CITY OF WESTFIELD, IN
Advisory Planning Commission Meeting Agenda 10_19_2015

MEETING DATE: Monday, October 19, 2015 at 07:00 PM

Grand Park Village – Lake Village Subdivision

CVS Pharmacy – Amendment

SOUTH ELEVATION

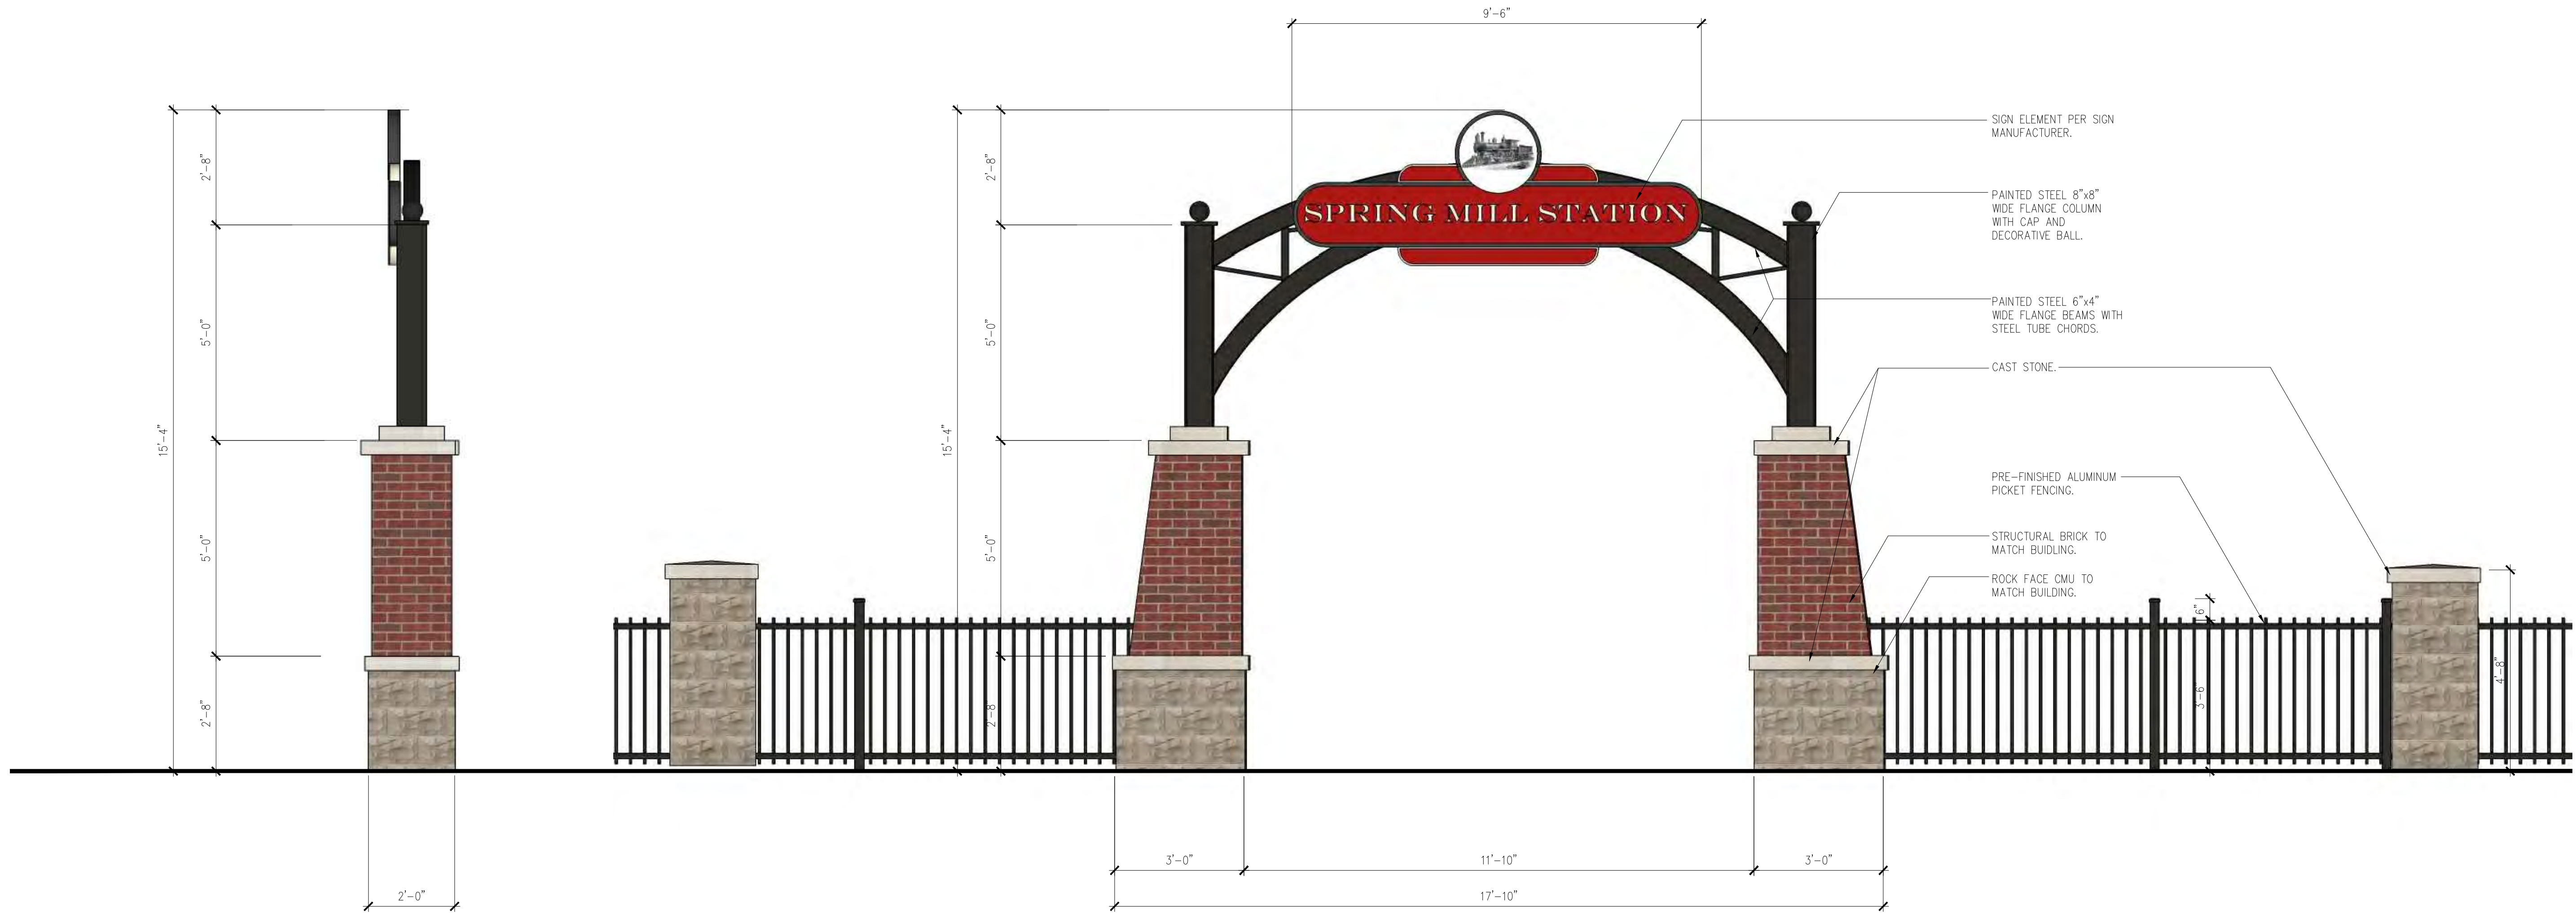
Comment: Window graphic designs not show on elevations. Asking that approval of the designs be delegated to staff with guidance from the Spring Mill Station Task Group.
